VIRGINIA ELECTRIC AND POWER COMPANY
RICHMOND, VIRGINIA 23261

SUBMITTAL OF ADDITIONAL INFORMATION
NRC IE BULLETIN 80-11 (MASONRY WALL DESIGN)
NORTH ANNA POWER STATION, UNIT NOS. 1 & 2

ADDITIONAL REFERENCES
NOT INCLUDED WITH
FRANKLIN RESEARCH CENTER REFERENCE LIST
ENCLOSURE TO NRC LETTER OF MAY 28, 1982
NORTH ANNA POWER STATION

NORTH ANNA POWER STATION

Development of Local Block Loading Criteria

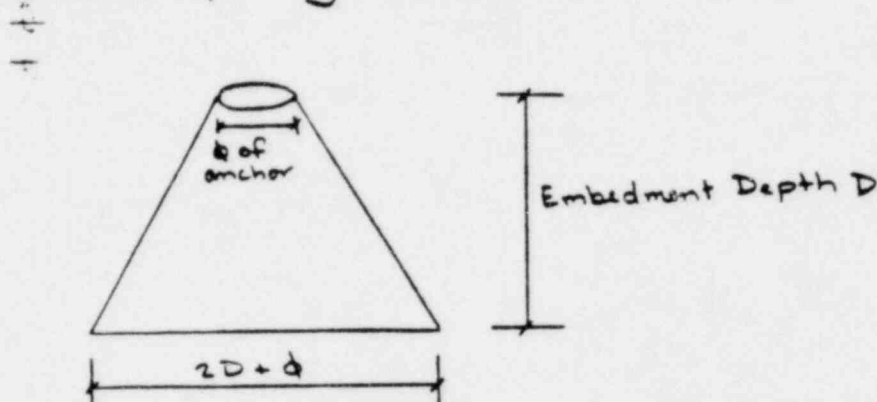
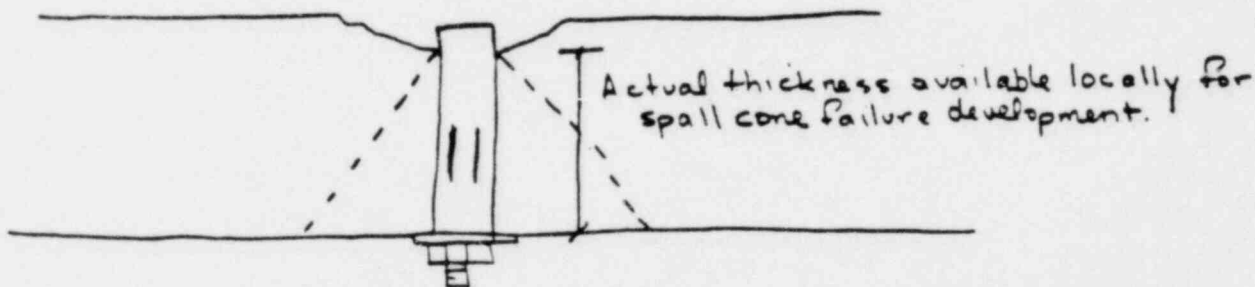
The question was raised by Mr B Khalifa whether or not ~~black~~ pullout needed to be considered in further local black criteria calculations. The black pullout values are considerably higher than other local criteria (shell face pullout, cone pullout etc) and will not be critical. Therefore, black pullout does not have to be considered in further calculations. This IOC and the back-up tables will be included as part of the engineering calculations 12846 cc STR-6.

By figure, spalling would vary as D^2 . However, test results do consider spalling caused by initial drilling which diminishes the thickness of the block locally where a spall cone would form.

Since development of spalling loads considered values where drilling had decreased the actual thickness to as low as 1.05" (where the lowest value of spall failure was found) on the Hilti 5/16" ϕ Sleeve Anchor, a linear decrease in strength values is considered to conservatively account for changes in thickness of the block and actual effective embedment depths approaching 1.0".
